Switch from obstacle_stop_planner to obstacle_cruise_planner #3964

Background

Proposal

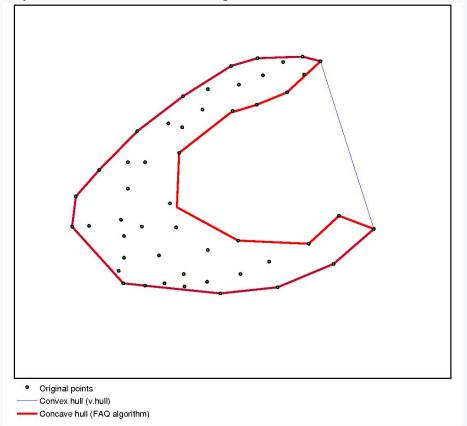
We should readjust the clustering params to make it at least act like the raw non ground point cloud.

Large obstacles are a problem. Convex hull will create issues.

Maybe we can use concave hull algorithms.

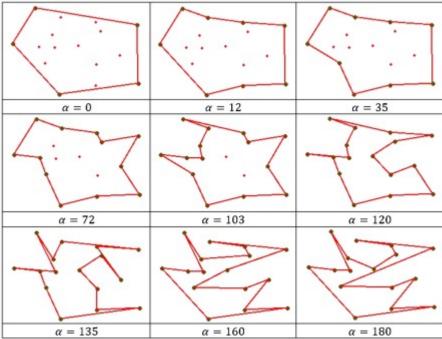
But the alpha value might be tricky and tuning might create issues.

Maybe we can cut large obstacles in pieces before assigning convex polygons.

But then, the velocity info can be wrong.

Maybe we can remove the detected objects from the raw non-ground point cloud and only have the small objects in the raw point cloud.
